**Advanced Passive 1000 (AP1000)
Generic Technical Specification Traveler (GTST)**

Title: Changes Related to LCO 3.7.6, Main Control Room Emergency Habitability System (VES)

Figure B 3.7.6-12 (page 1 of 1)
Compressed Air Storage Tanks Minimum Volume – One Bank of VES Air Tanks (8 Tanks)
Inoperable

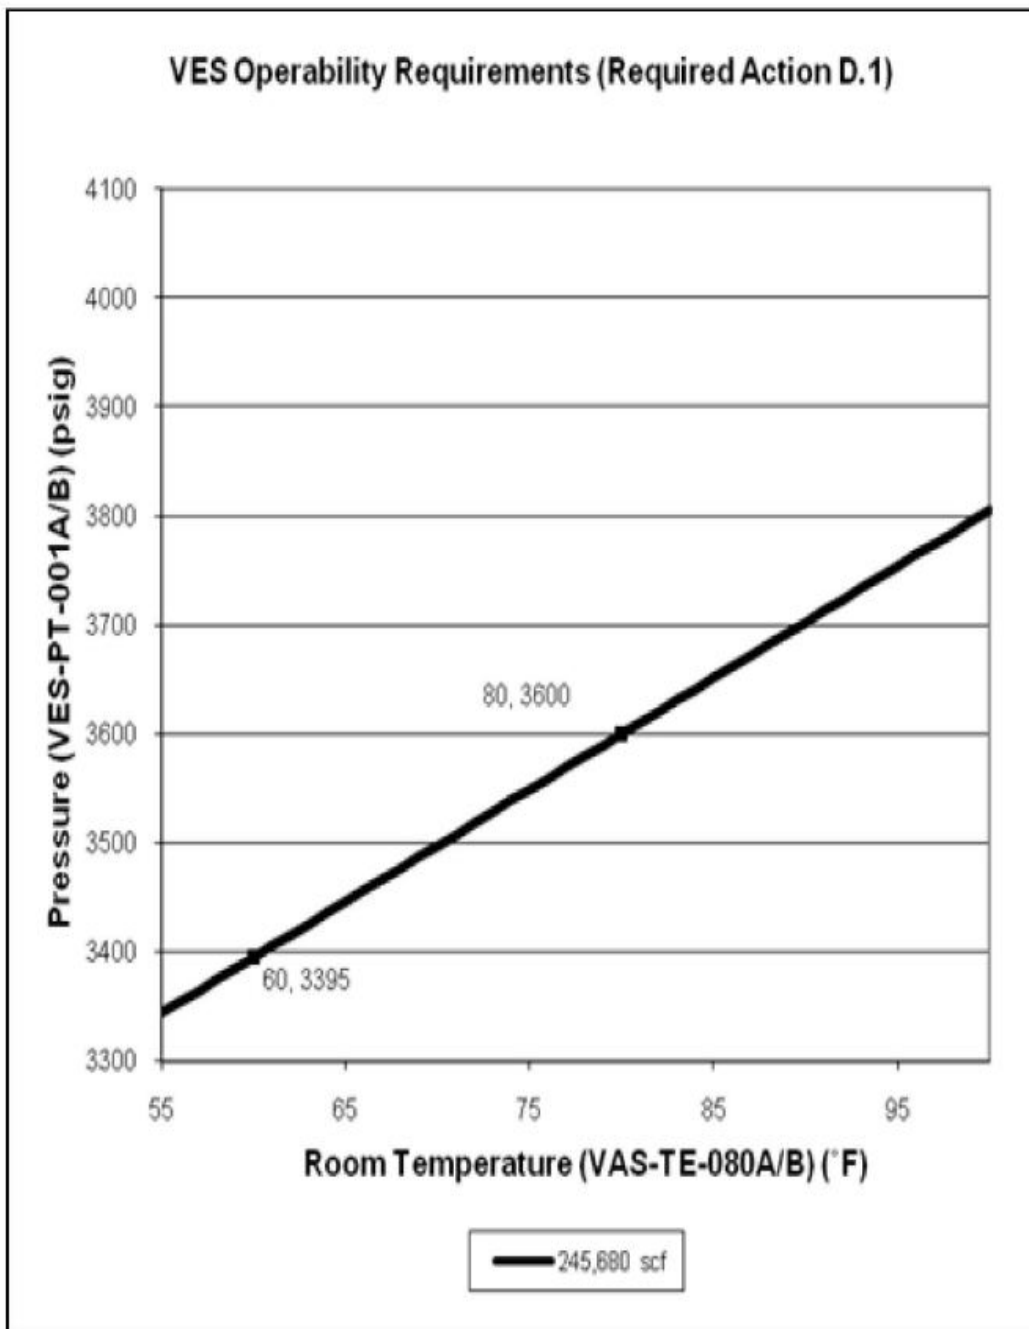
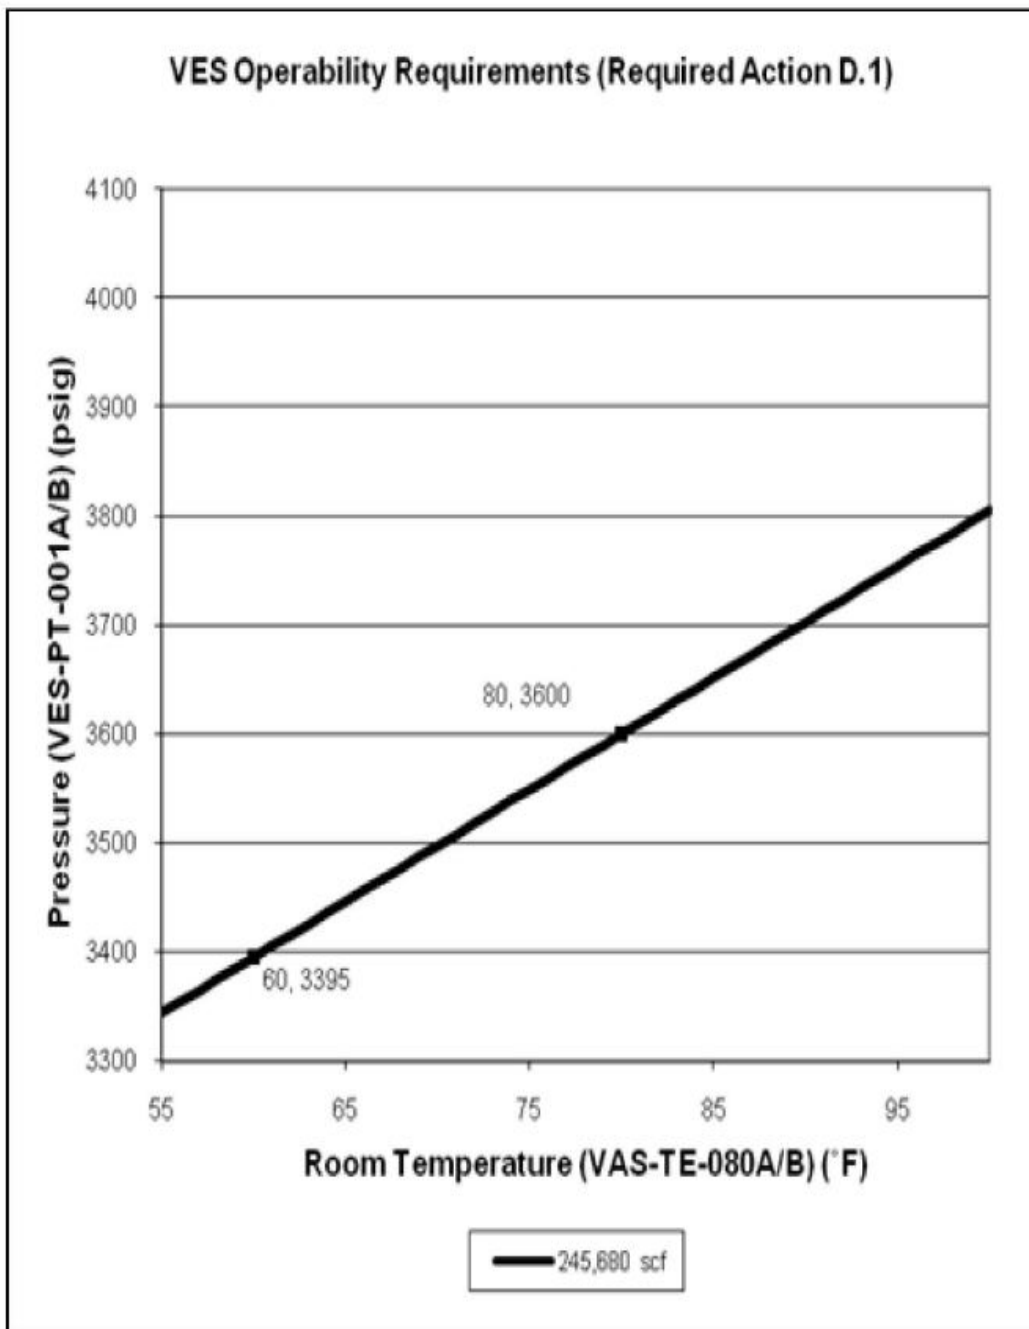
Figure B 3.7.6-2 is updated and renumbered as Figure B 3.7.6-1, and Figure B 3.7.6-2 is updated and renumbered as Figure B 3.7.6-1. (APOG Comment)

13. (Internal # 422 and 423) Revise TS Bases Figures B 3.7.6-1 and B 3.7.6-2 to add “Acceptable” region labels. The order of the Figures is swapped to align with Writer’s Guide convention. This is resolved by making the recommended change.
14. (Internal #1) Include TSTF-522 in the reference disposition tables, as “TSTF already included in GTS Rev. 19 with variation.” Note that minor changes to the Bases are as appropriate to the AP1000 design.

In addition, renumber Figure B 3.7.6-2 as Figure B 3.7.6-1, and Figure B 3.7.6-2 as Figure B 3.7.6-1. This non-technical change provides improved clarity, consistency, and operator usability. This is resolved by making the recommended change.
